CONTRACT CHANGE ORDER NO. ____
SHEET ___ OF ___

MARK	DATE	DESCRIPTIONS	BY	CH'D	CCO#
2	09/01/11	EAST END OBG	DT	GB	87
1	04/02/07	CROSSBEAM KINK	GB	DT	38

SAN FRANCISCO OAKLAND BAY BRIDGE
EAST SPAN SEISMIC SAFETY PROJECT
SELF-ANCHORED SUSPENSION BRIDGE
(SUPERSTRUCTURE & TOWER)

CROSSBEAM AT EAST ANCHORAGE NO. 2

CROSSBEAM PLAN AT TOP ANCHORAGE PLATE LEVEL 2

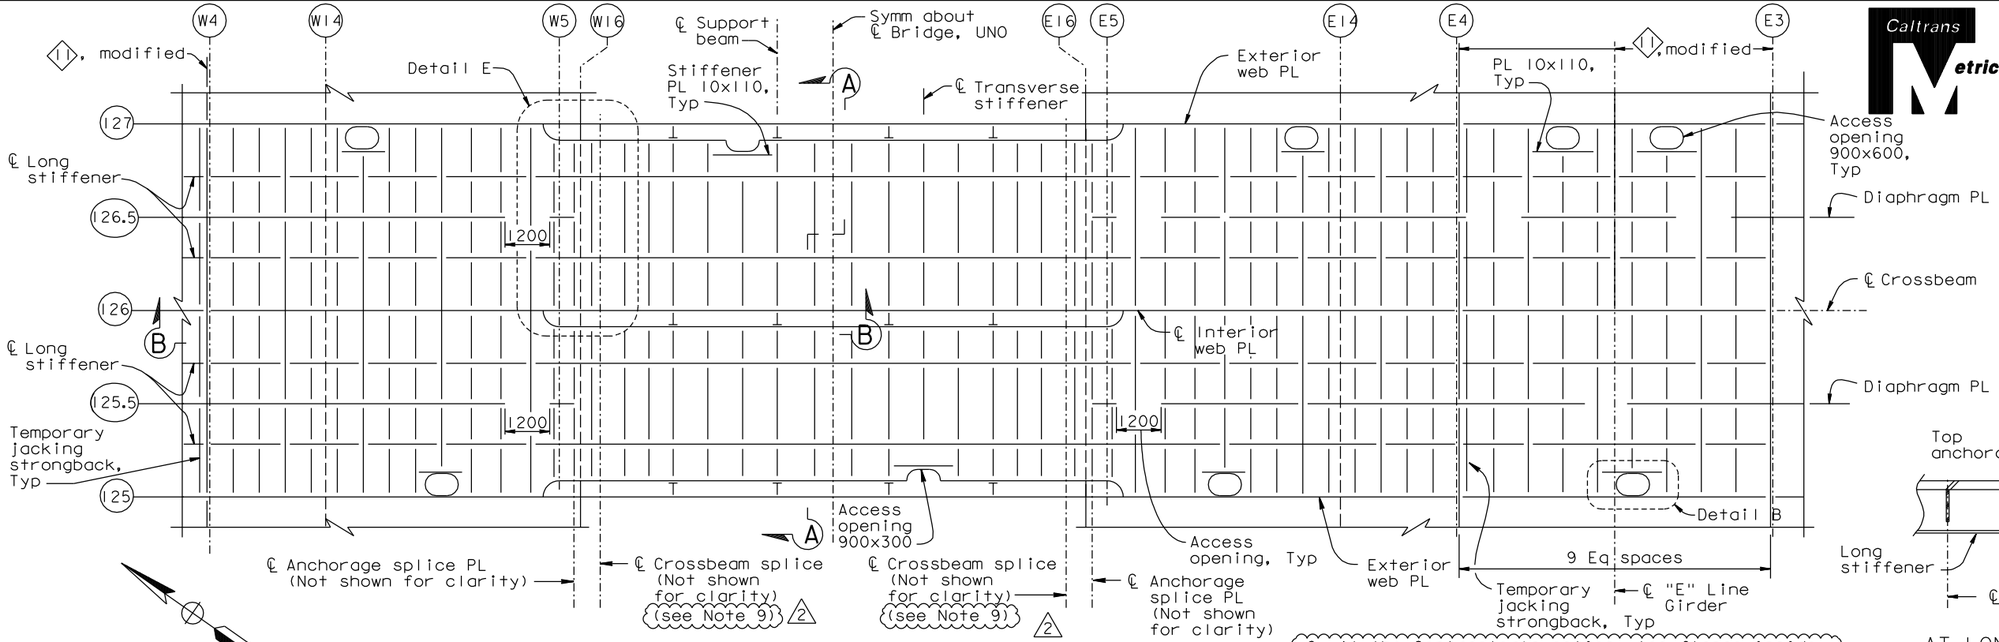
1. For girder details not shown, see "Girder At East Transition" and "Floorbeam At East Transition" sheets.
2. For crossbeam details not shown, see "Crossbeam At Pier E2" sheets. 2 At the Contractor's option, PL 22x200 plate stiffeners at the east anchorage crossbeam webs may be used in lieu of PL 22x205 plate stiffeners, subject to review and approval of the Engineer.

DETAIL A (See Note 8) 2

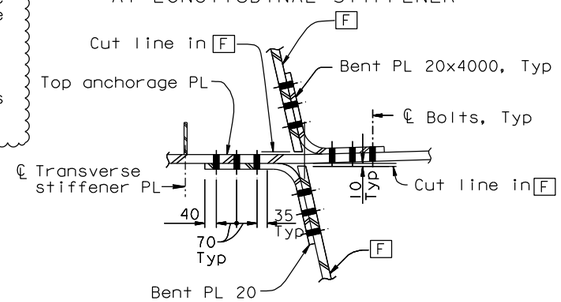
7. For Detail C, see similar Section B-B on "Typical Crossbeam Details No.4" sheet.
8. 2 For alternate Detail A, see "Crossbeam At East Anchorage No.3" sheet.
